DEVELOPMENT REVIEW BOARD REPORT

Dunkin Donuts 42-DR-2017

Request:

Request approval of the site plan, landscape plan, and building elevations for a new multi-tenant commercial building with approximately 3,000 square feet of building area and drive-through service, all on a 0.42-acre site within the existing Indian River

PHOTOMETRIC PLAN

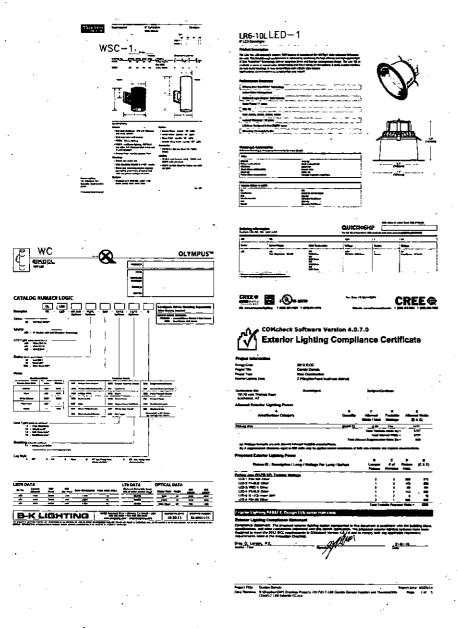
- a. The maintained average horizontal luminance level, at grade on the site, shall not exceed 2-foot-candles. All exterior luminaires shall be included in this calculation.

- b. The maintained maximum horizontal luminance level, at grade on the site, shall not exceed 8-foot-candles. All exterior luminaires shall be included in this calculation.

- c. The initial vertical luminance at 6-foot above grade, along the entire property line shall not exceed 0.8-foot-candles. All exterior luminaires shall be included in this calculation.
